STAFF REVIEW AND RECOMMENDATIONS
PUBLIC HEARING
JUNE 17, 2020

PRELIMINARY PLAT: CANDYWINE UNIT 1 RSB BLOCK 1 LOT 6
LEGAL DESCRIPTION: SEC 24, T17N, R01W, SEWARD MERIDIAN AK
PETITIONERS: BRENT & SUZANNE STOTT
SURVEYOR/ENGINEER: BESSE ENGINEERING
ACRES: 8.9 +/- PARCELS: 2
REVIEWED BY: AMY OTTO-BUCHANAN CASE #: 2020-065

REQUEST: The request is to create two lots from Lot 6, Block 1, Candywine Unit No. 1, Plat No. 2017-116 to be known as **LOTS 6A and 6B**, containing 8.9 acres +/- . The plat is located south of E. Fairview Loop, west of S. Candywine Road and north and west of S. Donovan Way; within the NW ¼ Section 24, Township 17 North, Range 01 West, Seward Meridian, Alaska.

TEST BORING LOCATION MAP

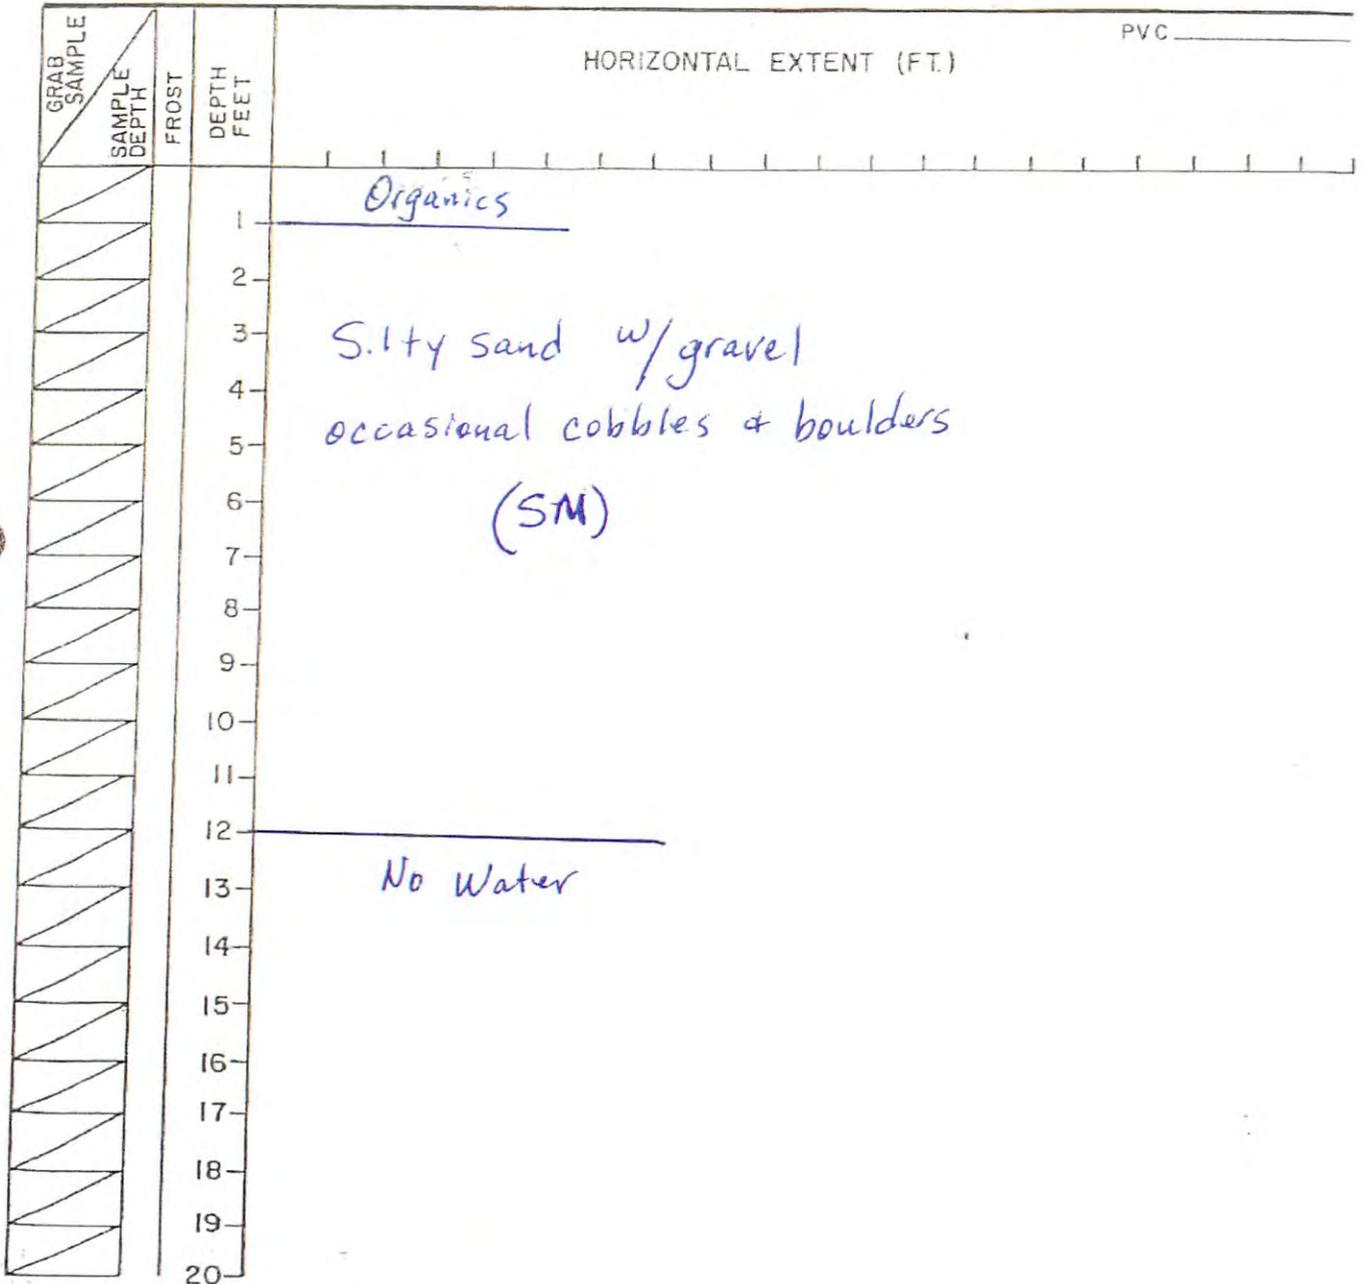
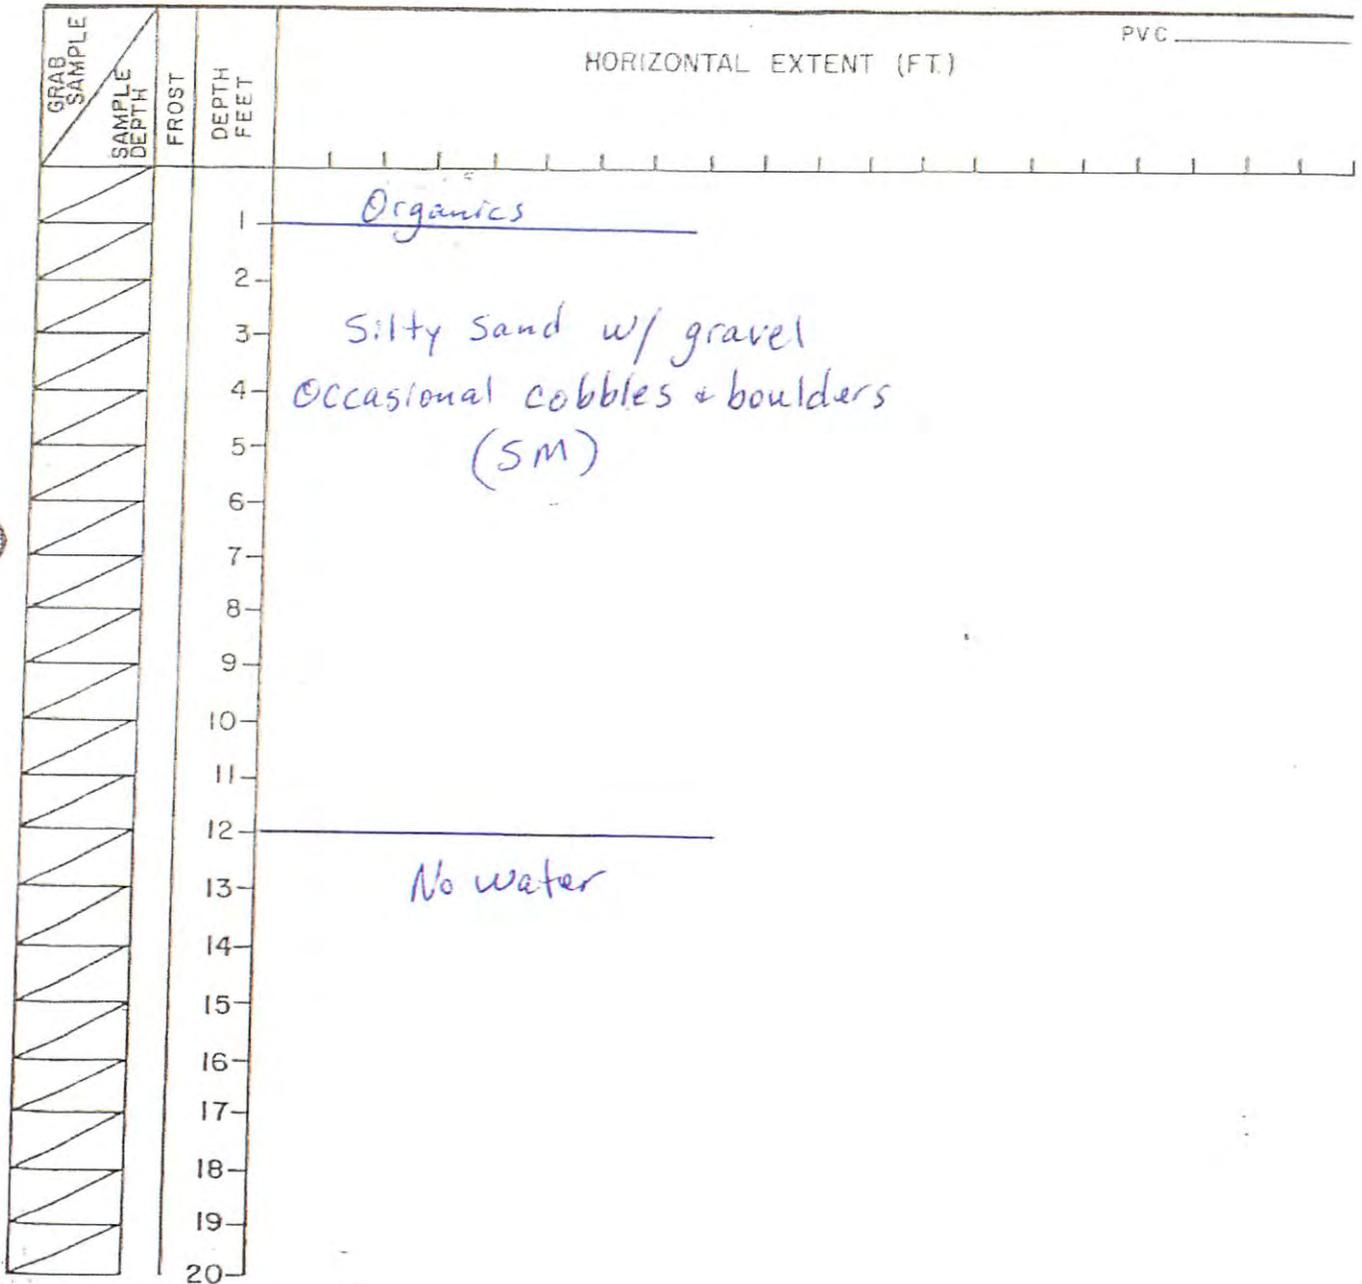
The soil logs show SM soils but there are no sieve analyses included as required by code. One test hole notes a percolation test was done, but the results of that test are not included. More information is needed.

Comments: Department of Public Works Operations & Maintenance (**Exhibit C**) notes the soils log shows SM soils but there are no sieve analyses included as required by code. One test hole notes a percolation test was done, but the results of that test are not included. More information is needed. *Staff notes the sieve analysis for the two testholes have been provided.* Planning Division (**Exhibit D**) has no comments.
